DEPARTMENT OF TRANSPORTATION**National Highway Traffic Safety Administration****49 CFR Parts 571 and 585**

[Docket No. NHTSA–2011–0004]

Federal Motor Vehicle Safety Standards, Ejection Mitigation; Phase-In Reporting Requirements; Incorporation by Reference

ACTION: Final rule.

Figure 14 – Side daylight opening of a MY2010 Chevrolet Camaro - Showing initial and final vertical targets and final horizontal targets.

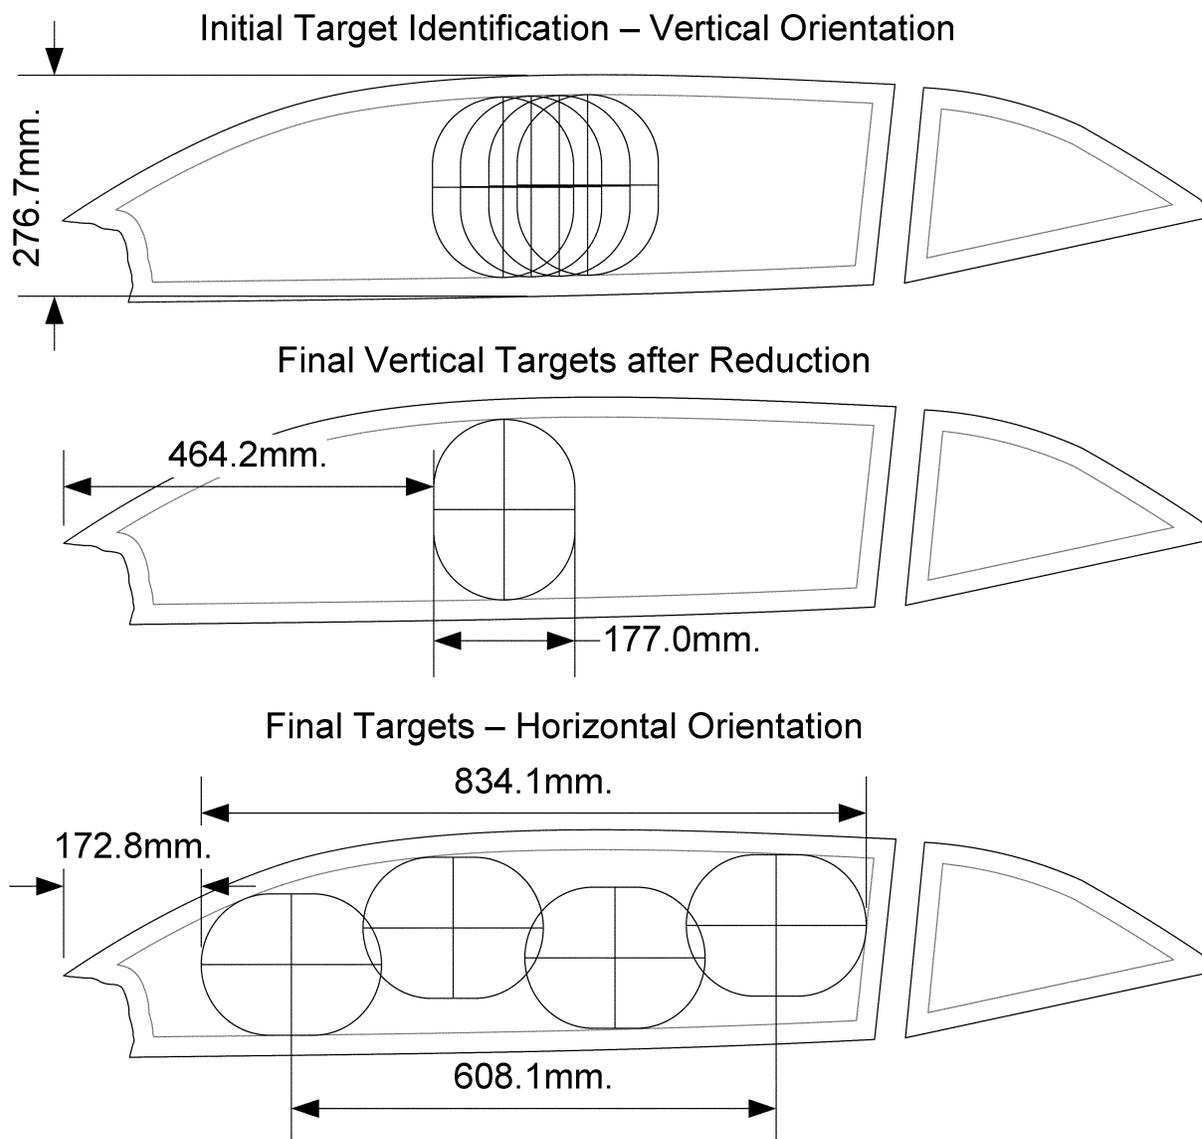
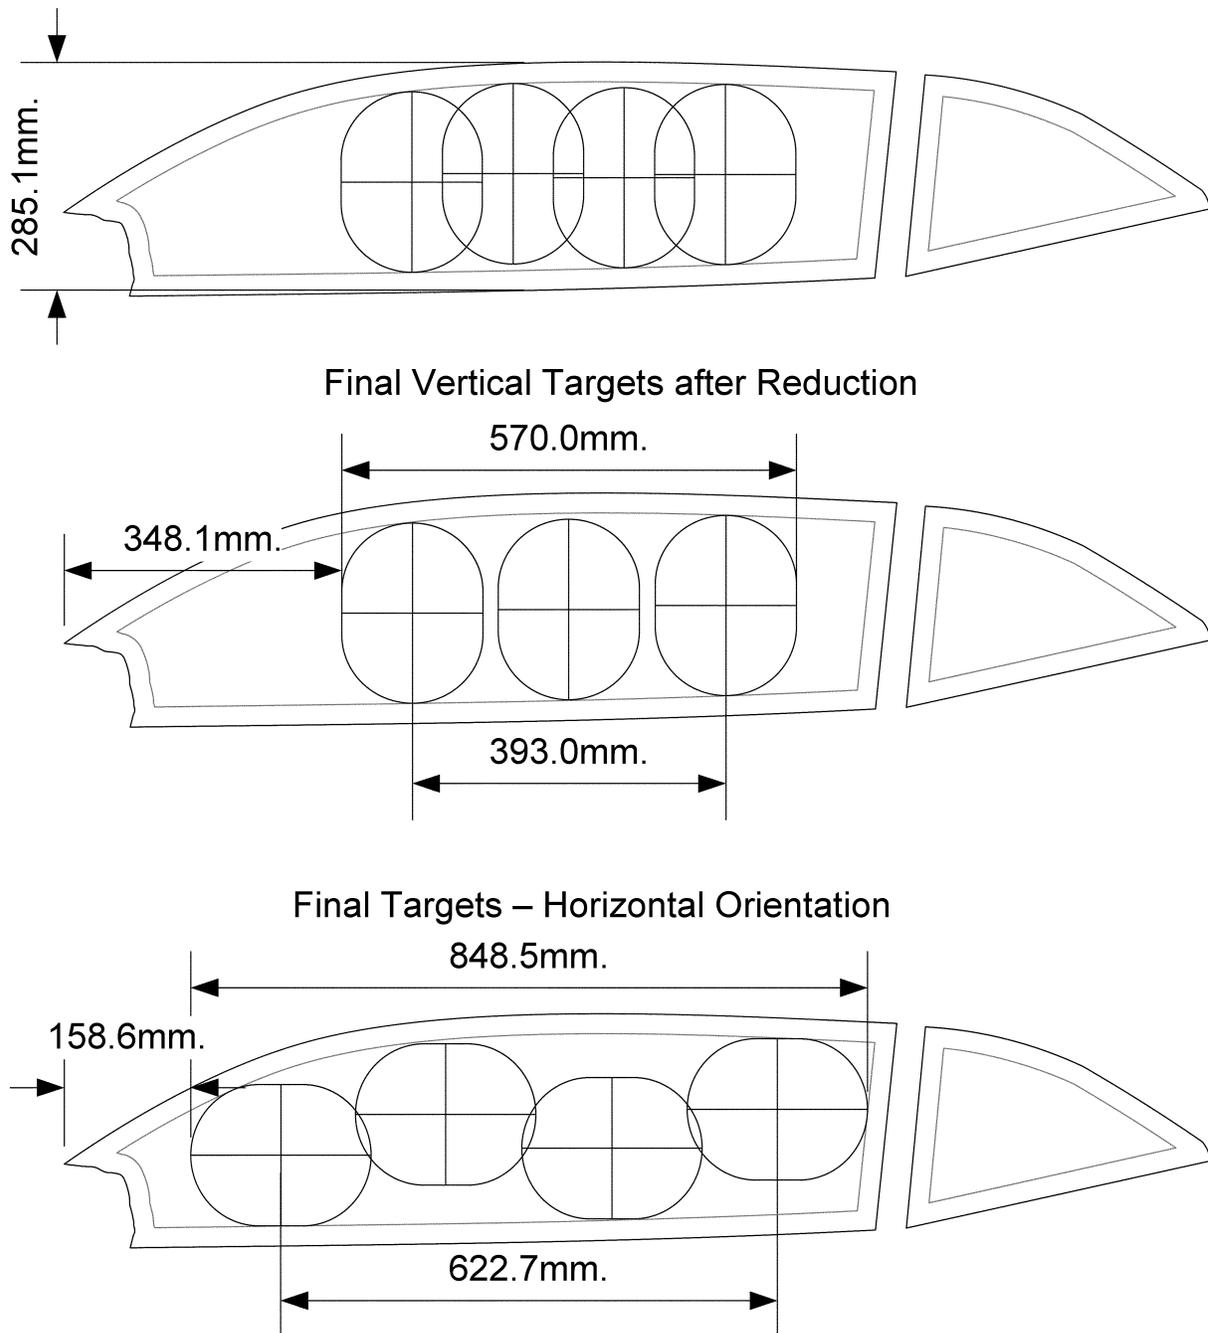
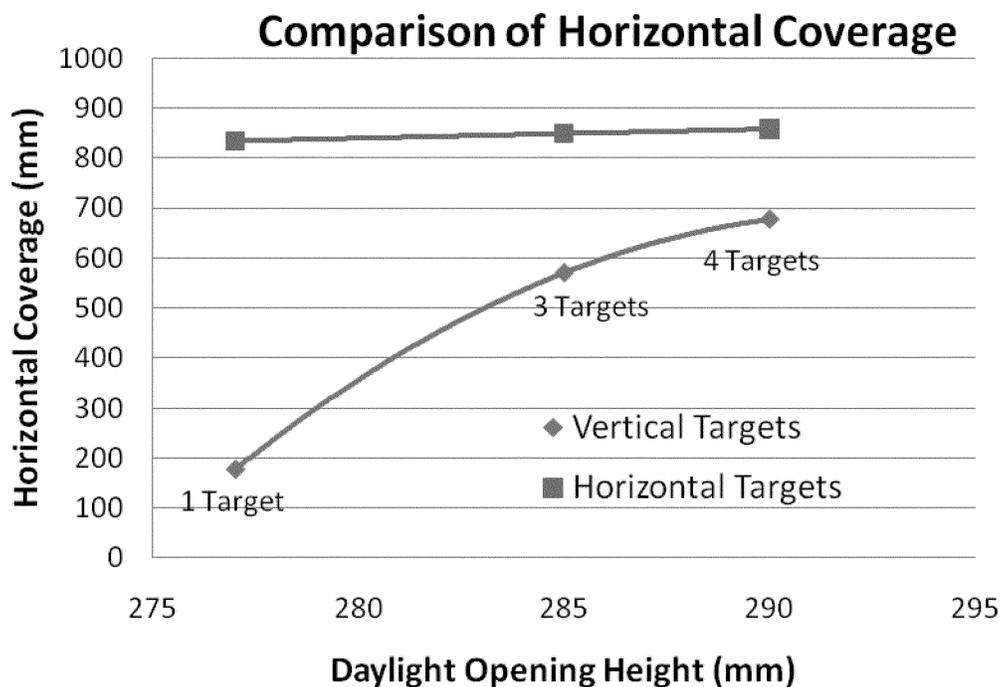
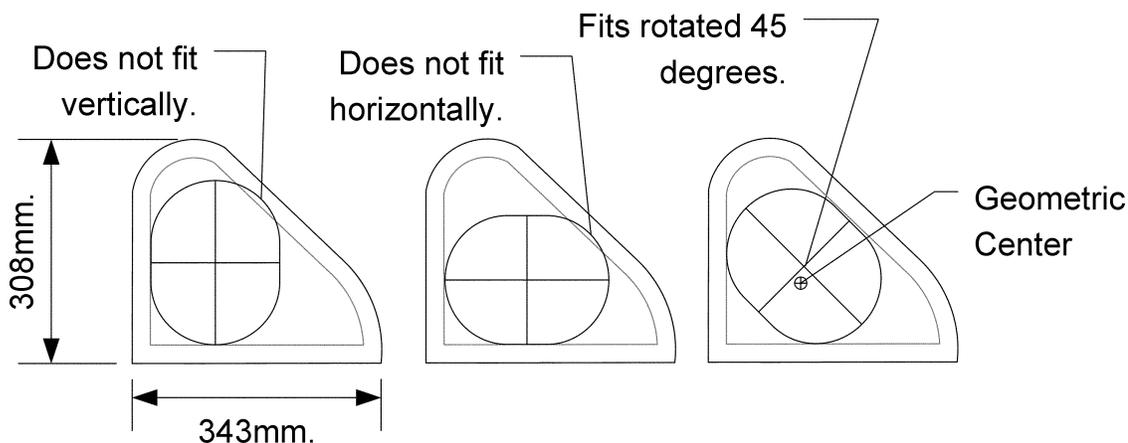
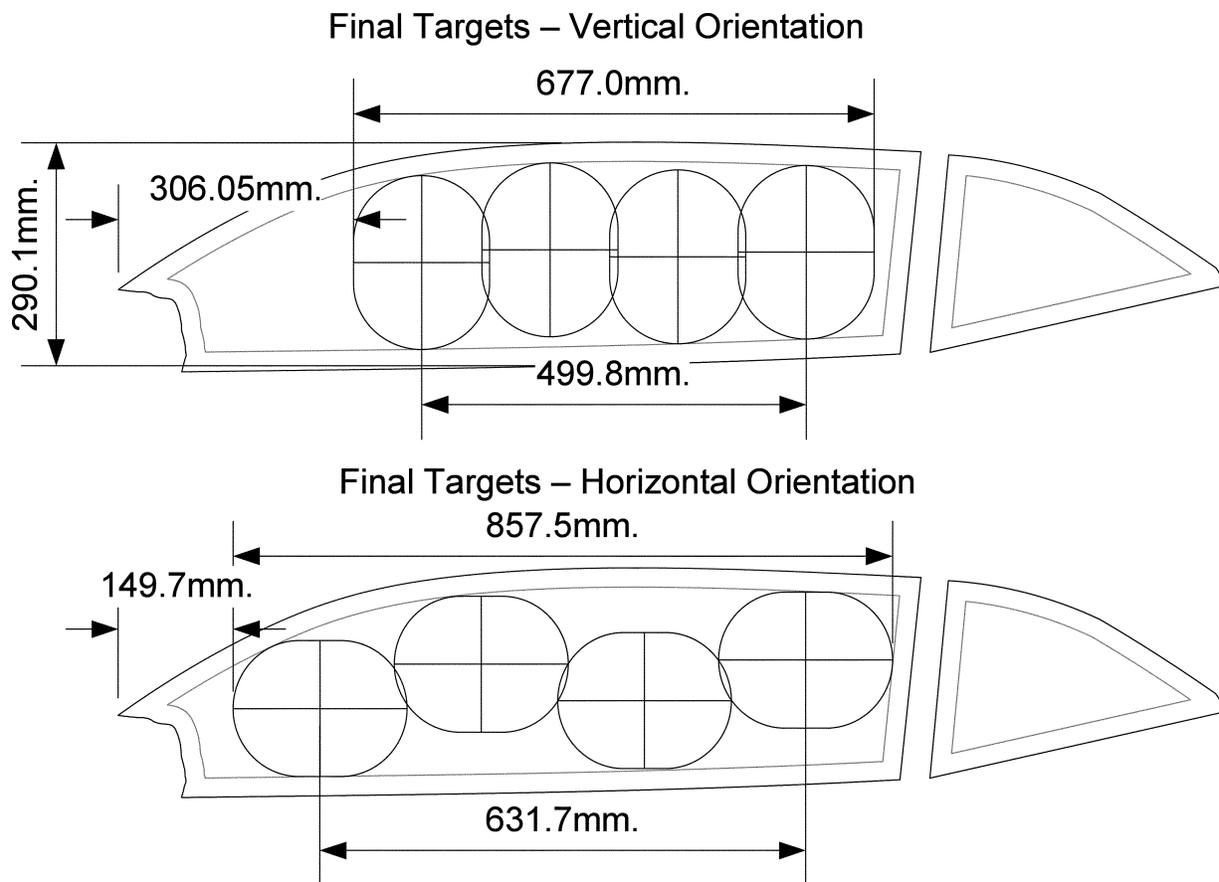
If the targeting procedure defined in the NPRM is followed, the four initial target locations (primary and secondary targets) are as shown in the top graphic in Figure 14. (The procedure is explained in detail in the NPRM at 74 FR at 63205–63211.) Under the NPRM procedure, if the horizontal distance between target centers is less than 135 mm and the vertical distance between target centers is less than 170 mm, the targets are considered to be significantly overlapping and are eliminated. At the

Figure 15 shows the result of the NPRM's targetting process with the vertical dimension of the daylight opening increased by 3 percent (from 277 mm to 285 mm). The four initial vertical target locations are shown in the top graphic. The target elimination process results in the two middle targets being removed but under the target reconstitution process a target is

Figure 16 compares the horizontal coverage (dimension from leading edge of most forward target to the trailing edge of the most rearward target) of the

target. Figure 17 depicts a daylight opening that is too small to fit a vertically oriented target outline within the offset line. Under the NPRM targeting procedure, such a daylight opening would not be impacted.

From the examples shown in the technical analysis above, any situation where fewer than four vertical targets can be placed in the daylight opening would allow for unacceptably large gaps in coverage. As shown in Figure 15, *supra*, the 3 vertically-oriented targets had 279 mm less horizontal window coverage than did the 4 horizontally oriented targets and the forwardmost horizontal target was 189 mm more forward than the vertical target.

from vertical to horizontal when the same number of targets can be placed in the daylight opening in either orientation. This is so even though in some cases, it is possible that the horizontal targets provide more horizontal coverage of the window opening. There are several reasons for this decision.

First, regardless of target orientation, if the same number of targets can be placed within the window opening then the area being impacted in both cases would be essentially the same. For example, looking at Figure 18 below, the target outlines impact approximately the same amount of area in the window opening. What differs is the distribution of the targets within the opening, which is solely a function of the opening shape. The horizontal targets cover more of the window opening towards the bottom of the A-pillar and the vertical targets more fully cover more of the remaining areas of the window.

Third, there are window openings that would otherwise not accommodate a target unless the target outline is rotated to some oblique angle. See Figure 17. We find it objectionable not to specify that the impactor may be rotated.
